AMENDMENTS TO THE DRAWINGS:

Please note the proposed corrections to Figs. 1-7, 11 and 25 as shown in red on the copies of the drawings attached herewith. Specifically, applicant proposes to amend the drawings as follows:

FIG.1  
Prior Art

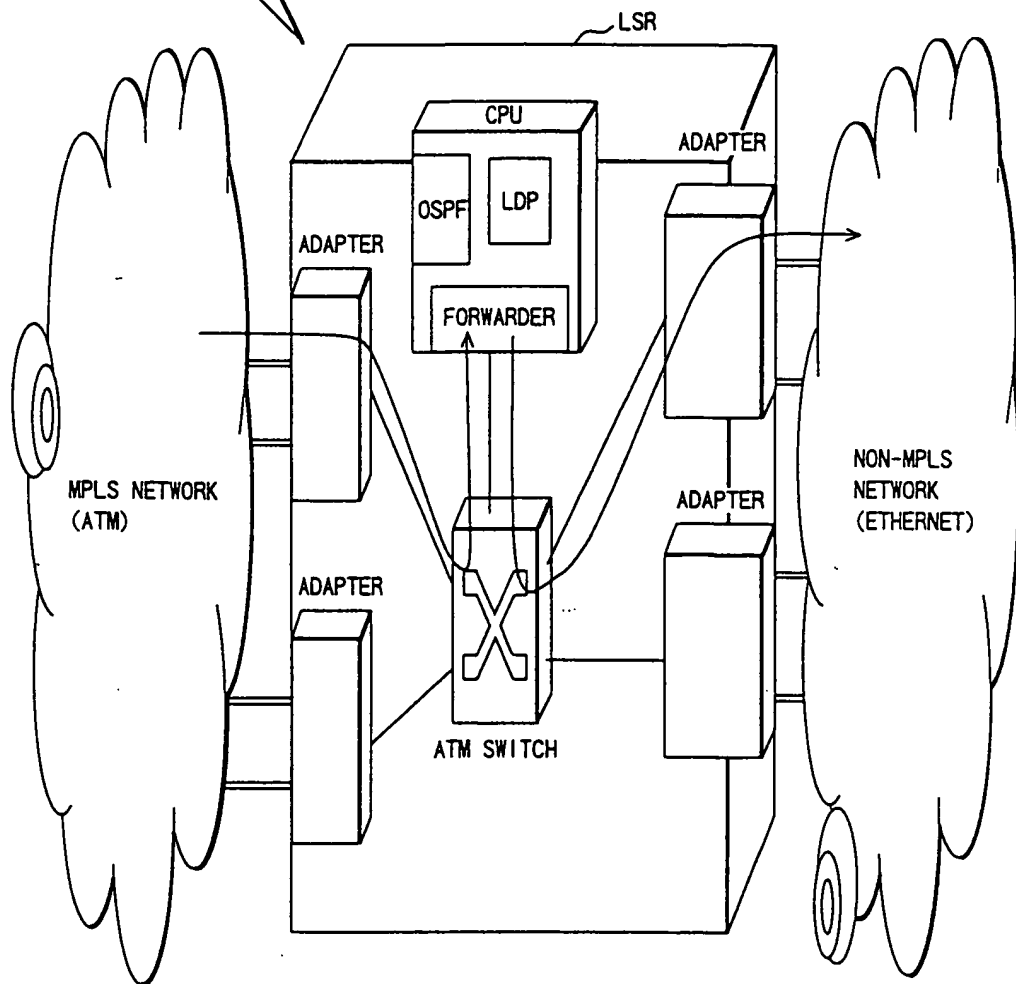
- (1) In FIGS. 1 – 7, add “PRIOR ART”,
- (2) In FIGS. 5 – 7, change “LABAL” or “LABLE” to --LABEL--,
- (3) In FIG. 11, interchange “PORT GROUP 3” and “PORT GROUP 4”, and
- (4) In FIG. 25, change “80 FORWARDER” to --80 FORWARDER (X)--.
